The Commission has issued the enclosed Amendment No. 69 to Facility Operating License No. DPR-26 for the Indian Point Nuclear Generating Unit No. 2. This amendment consists of changes to the Technical Specifications in response to your applications transmitted by letters dated April 25, 1980 and March 26, 1981.

INDIAN POINT NUCLEAR GENERATING UNIT NO. 2

AMENDMENT TO FACILITY OPERATING LICENSE

Amendment No. 69
License No. DPR-26

Figure 3.10-2 a

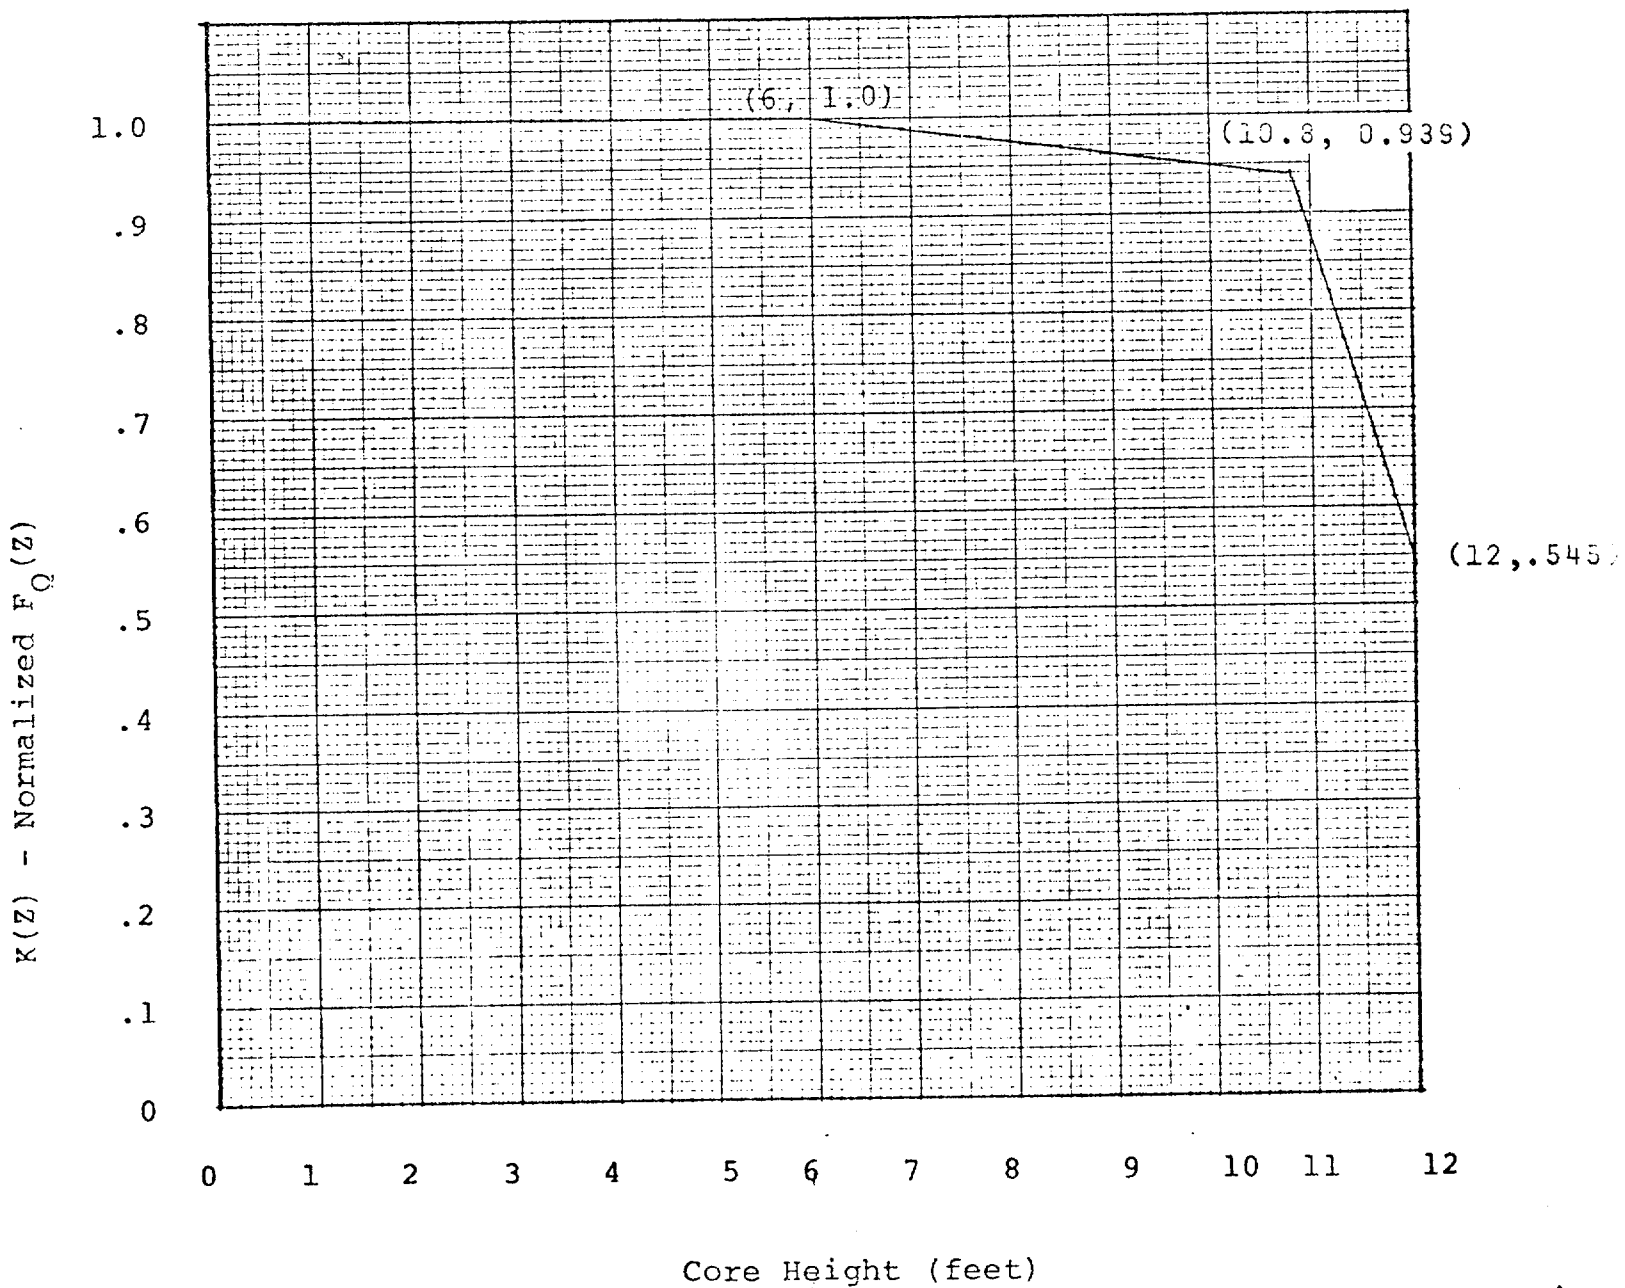
where P is the fraction of full power at which the core is operating; K(Z) is the fraction given in Figure 3.10-2a (for $\leq 6\%$ tube plugging) or Figure 3.10-2b (for $> 6\%$ but $\leq 12\%$ tube plugging); and Z is the core height location of F_Q .

(b) For $\leq 6\%$ steam generator tube plugging:

$$F_Q(Z) \leq (2.31/P) \times K(Z) \text{ for } P > .5$$

$$F_Q(Z) \leq (4.62) \times K(Z) \text{ for } P \leq .5$$
